RE: Mt. Skukum Gold Mine
Inspection of Tailings Ponds

This letter-report summarizes observations made during the June 15, 1987 site visit of the above mine. The purpose of the site visit was to examine the tailings facilities in detail for surface features which may be indicative of the probable future performance of these structures.

FIG. 1

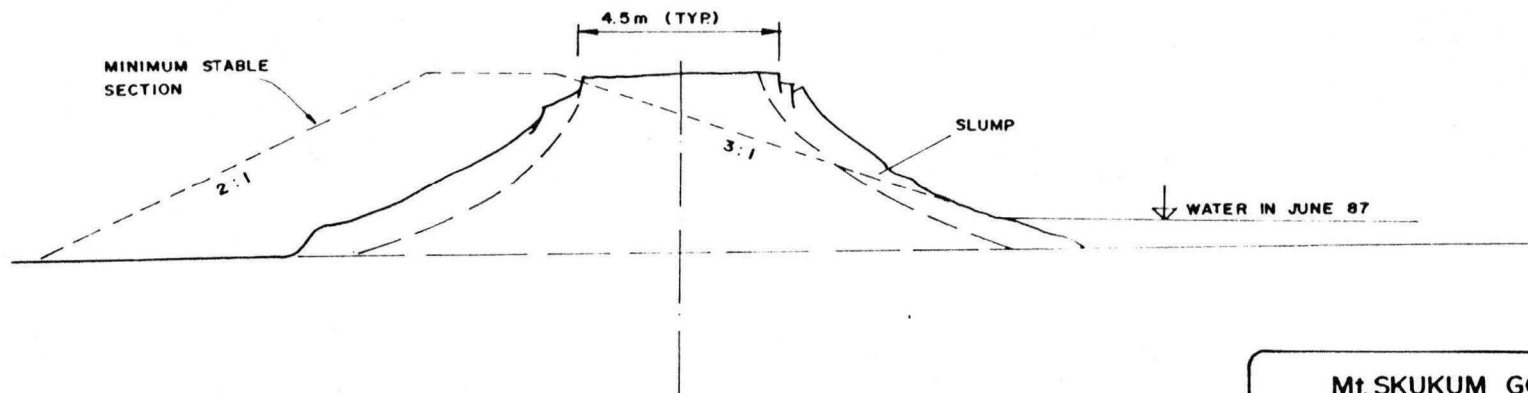
- ° Dyke No. 1 (Figure 1) is approximately 300 m long and up to 5 m high. It will eventually impound tailings to elevation 989.5 m. The dyke crest is 5 m wide, the freeboard is 0.5 m and the dyke slopes were designed 1.5:1 (H:V).
- ° Dyke No. 3, approximately 100 m long and only 2 m high, is blocking a terrain depression at the northeast corner of the designated tailings pond area. The crest is 3 m wide and slopes are 1.5:1.

dyke. The downstream toe is locally cracked and bulged, indicating slope and/or foundation failure (Photo Nos. 1 and 2).

A schematic sketch of current dyke deformations is shown also on Figure 1 together with a dyke configuration which would meet the above guidelines.

- placement of additional fill on the downstream side of the dyke to compensate for the poor quality of the embankment fill and achieve a stable downstream slope;
- grading of the upstream dyke faces to achieve a more stable slope;
- placement of additional fill and grading of the dyke crests to achieve the designed grade;
- construction of properly armoured spillways;
- initiation of a regular monitoring program.

Photo 5: Dyke No. 2 - looking west. Cracks at the crest are caused by the unstable upstream dam slope.

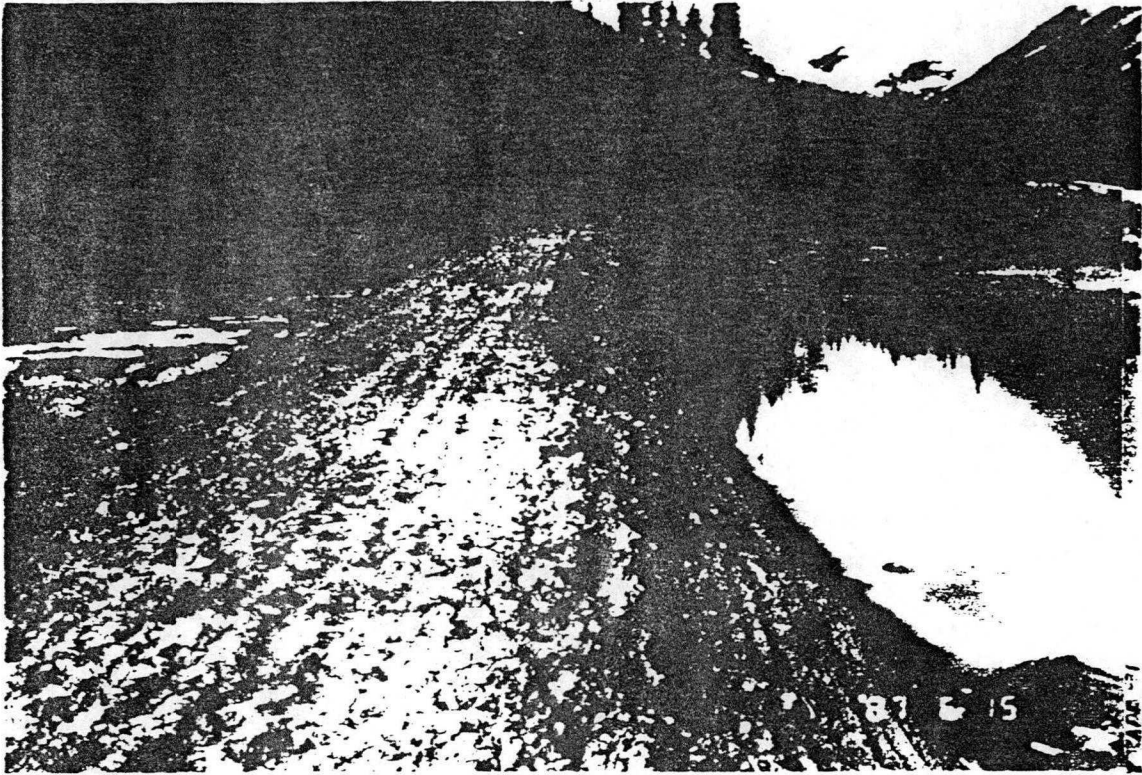
The dyke is comprised of clayey silt, similar to the material used for the main dyke. Its sideslopes are steep, approximately 1.5:1 (H:V), fissured and cracked. The overall stability of the dyke is marginal (Photo Nos. 5 and 6) and localized dyke sections are currently unstable.
